**FINAL**  
**Fourth Five-Year Review Report**  
**for**  
**Sacramento Army Depot**  
**Sacramento**  
**Sacramento County, California**

**July 2012**

**THE DEPARTMENT OF THE ARMY**  
**ASSISTANT CHIEF OF STAFF FOR INSTALLATION MANAGEMENT**  
**BASE REALIGNMENT AND CLOSURE DIVISION**  
**600 ARMY PENTAGON**  
**WASHINGTON, DC 20310-0600**

FIGURE  
**6**

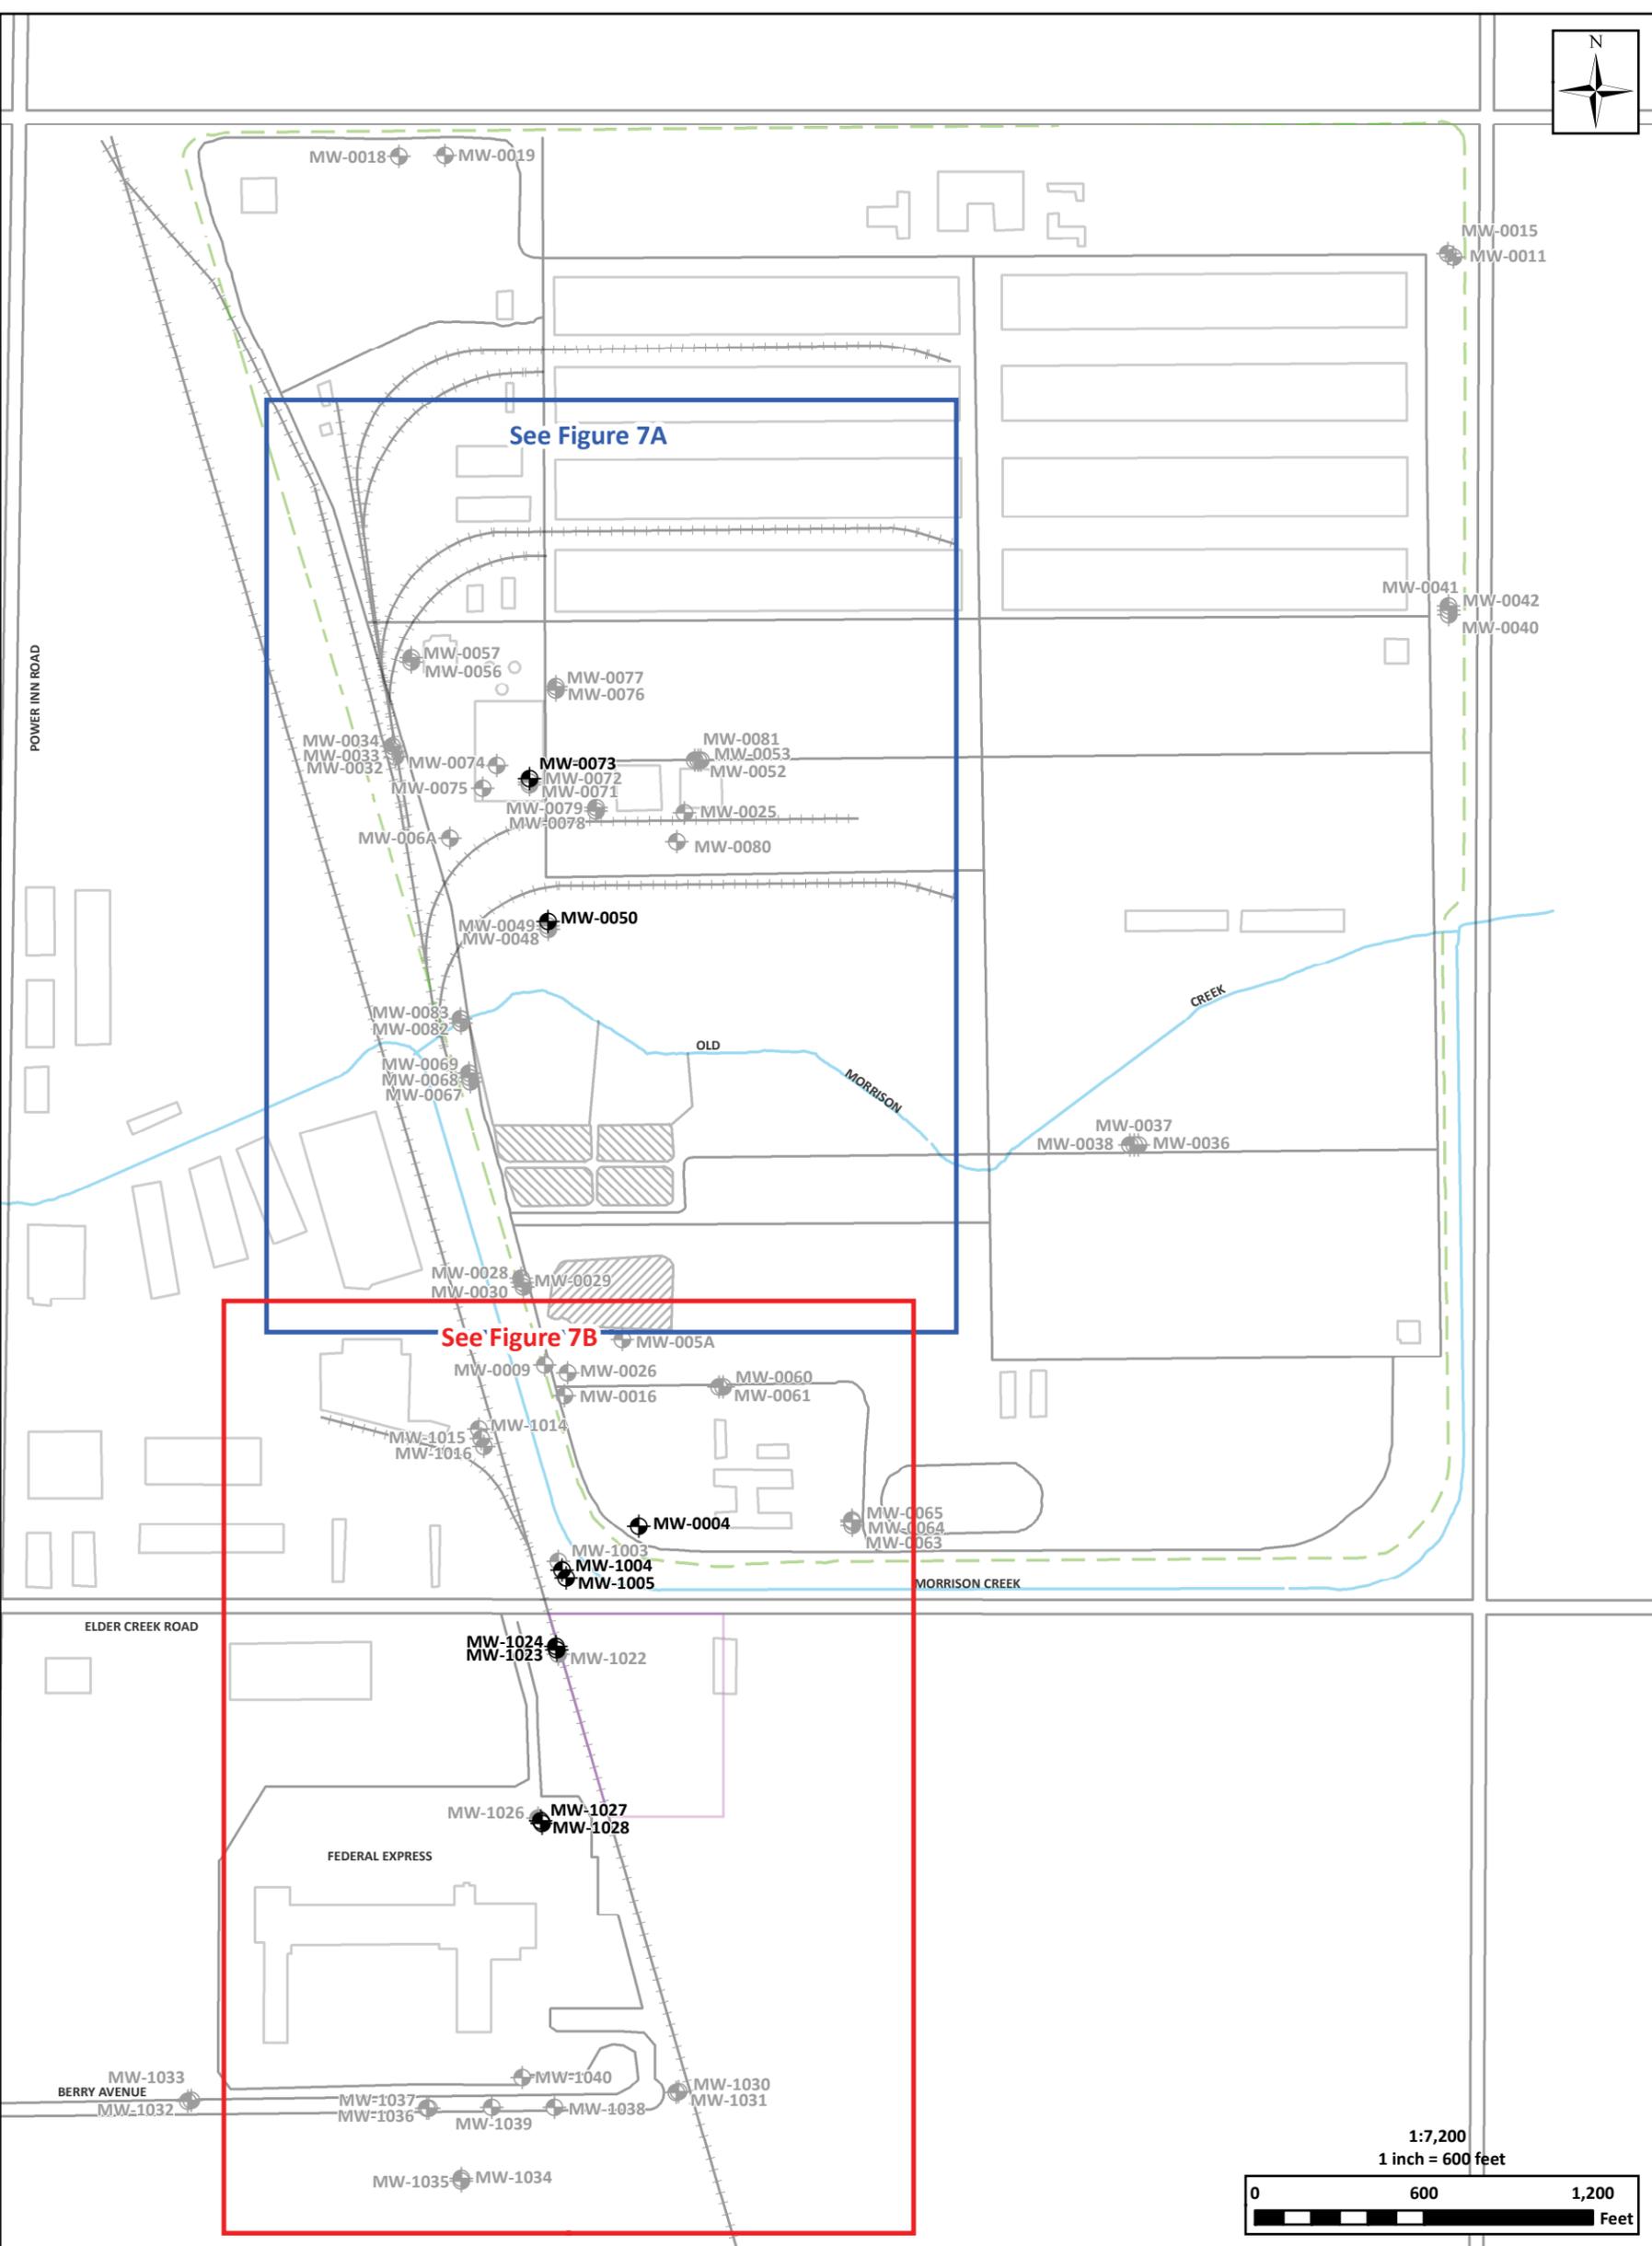
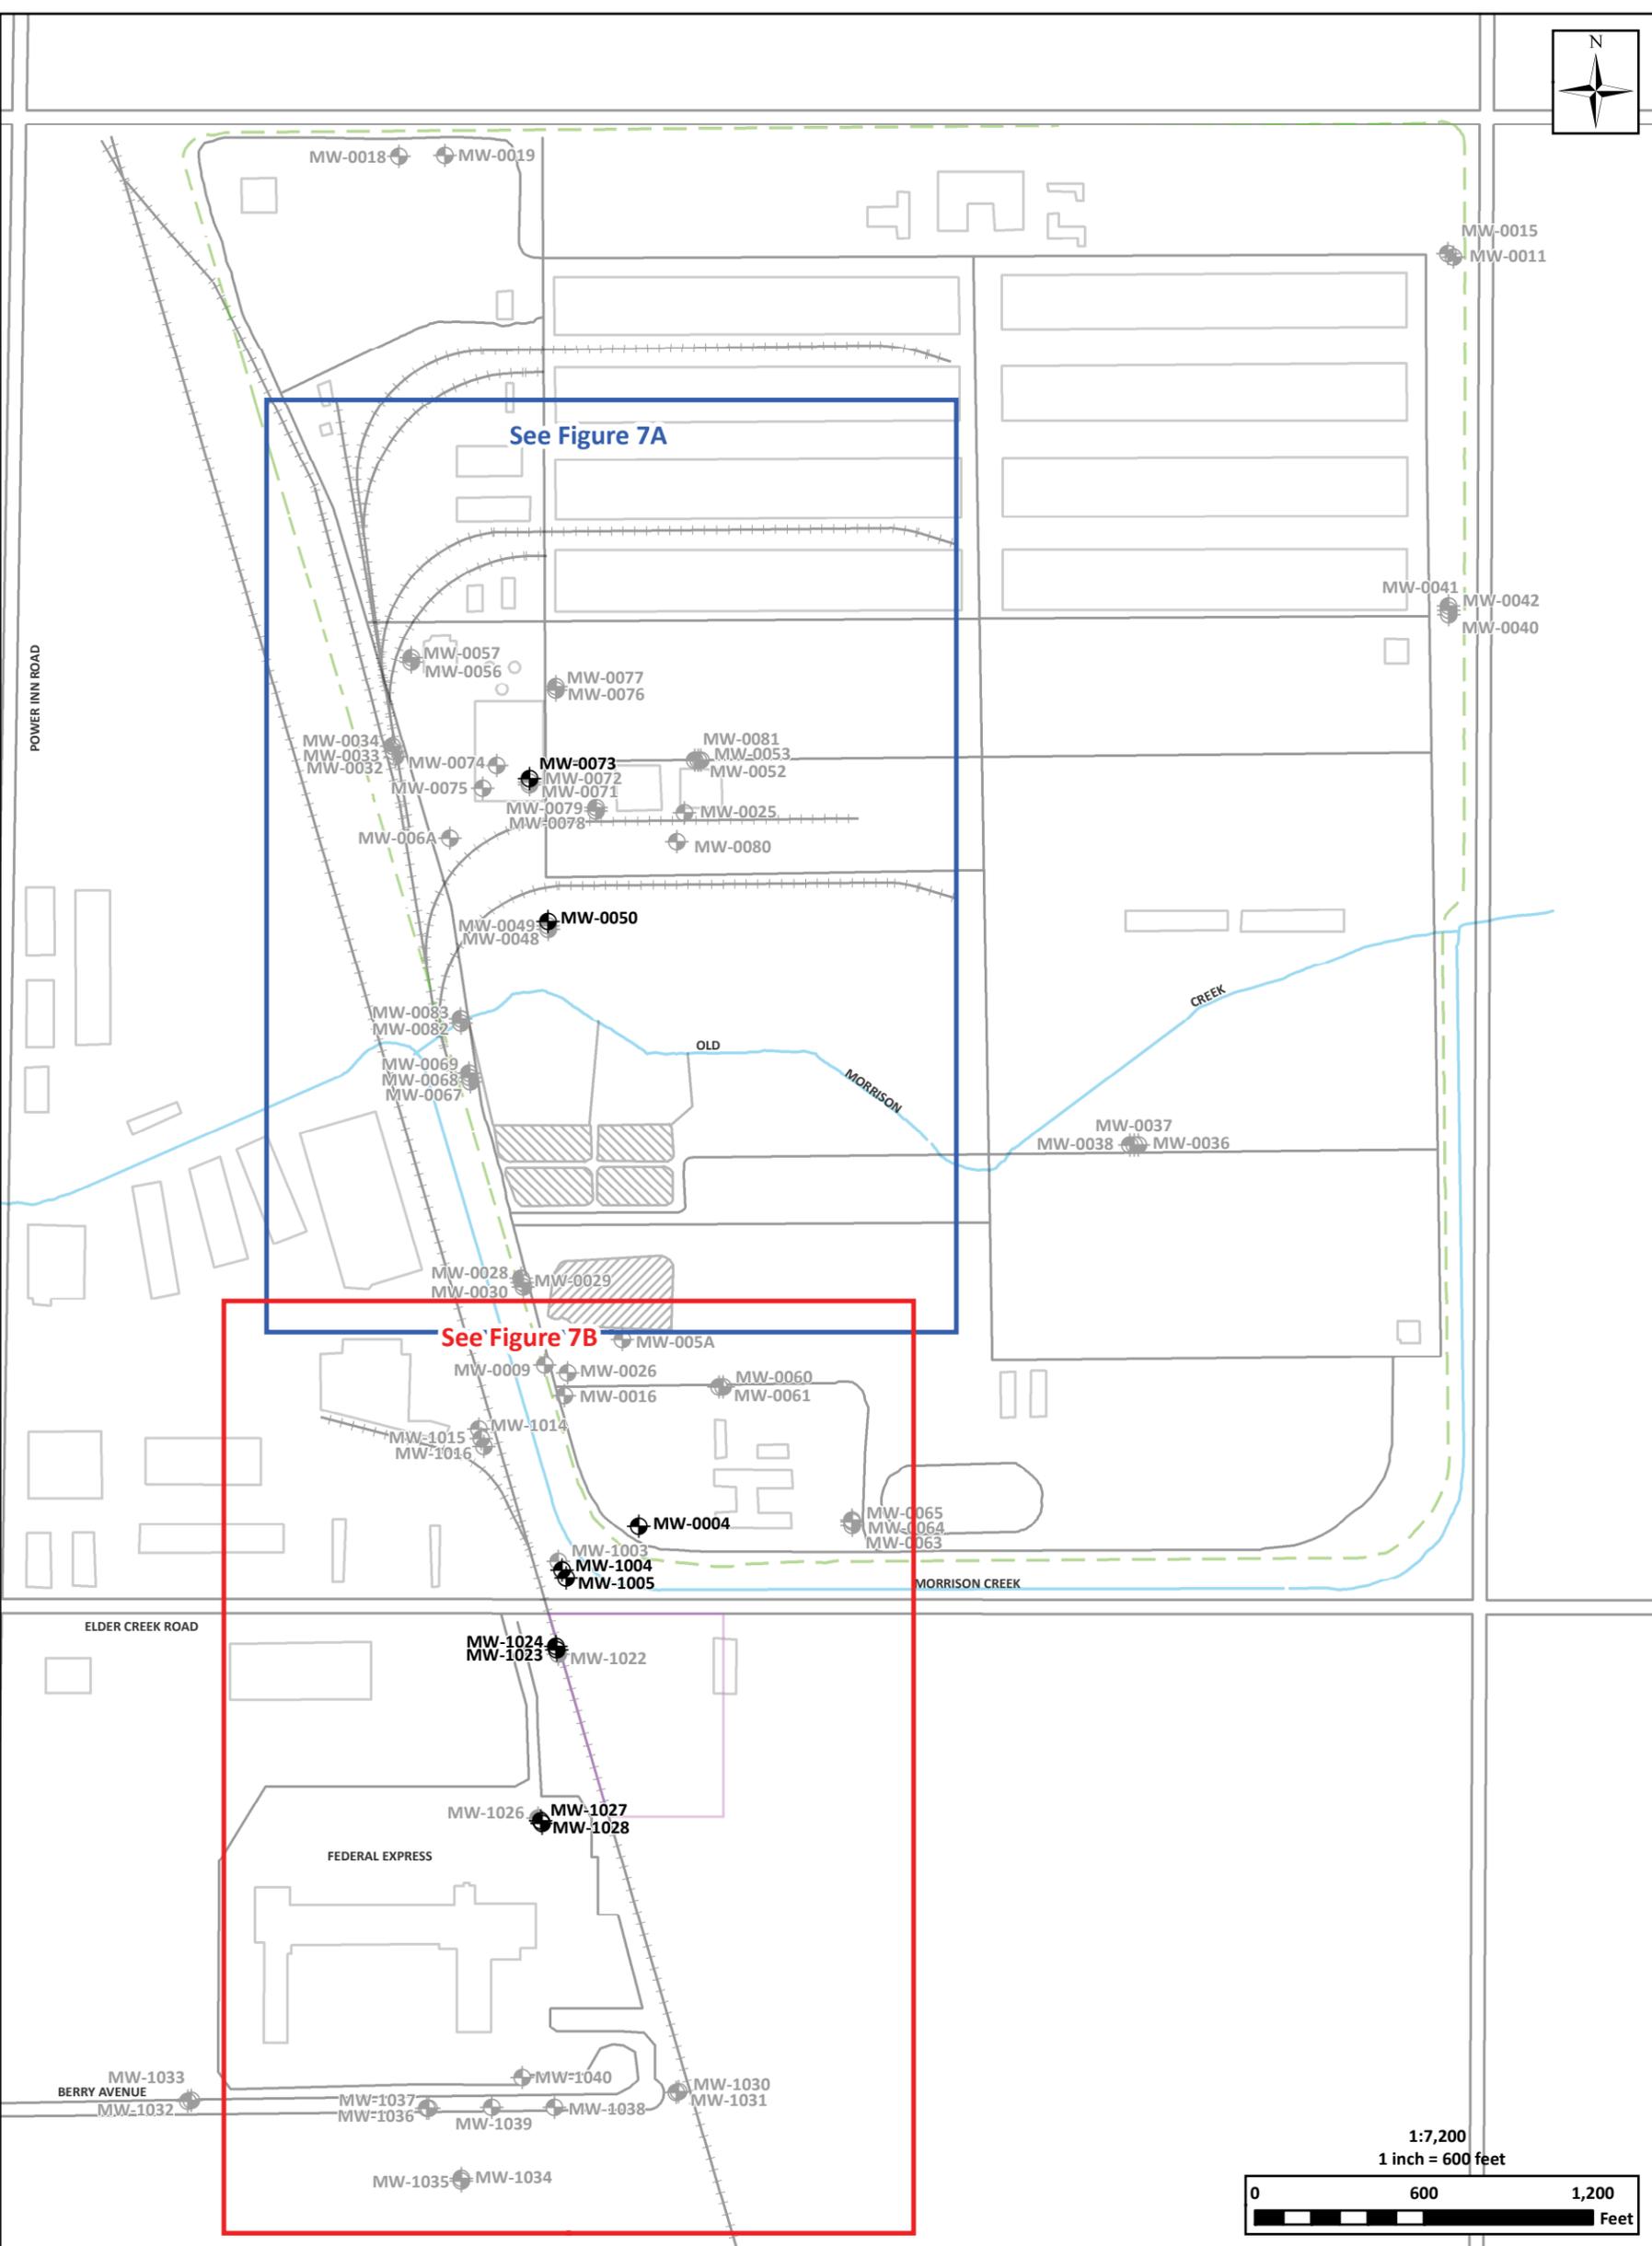
11	Figure 6, Berry Avenue Groundwater Extraction System Capture Zone	“Capture zone analysis should be conducted in accordance with the EPA guidance document, A Systematic Approach for Evaluation of Capture Zones at Pump and Treat Systems, dated January 2008. Please ensure that the capture zone analysis is consistent with this guidance document.”	<b>A</b> The capture zone induced by the Berry Avenue Groundwater Extraction System (BAGES) was evaluated per the referenced EPA guidance and was documented in the Technical Memorandum that was finalized in April 2012.
<b>MINOR COMMENTS</b>

e.	Figure 6	“Figure 6: If the above referenced figures are not generated, recipients of the five year review may erroneously view the ellipse shaped capture zone on Figure 6 to represent the plume. To rectify this, the Army should delete the ellipse and replace this with the current plume. To demonstrate capture of the B zone plume, a bounding flow line should be delineated along the west of the plume in addition to the eastern line currently shown. When complete, the revised figure will show a capture zone (as supported by data), versus a "target" capture zone which is neither a plume nor an empirically supported shape.”	<b>A</b> The suggested revisions will be made to <b>Figure 6</b> .
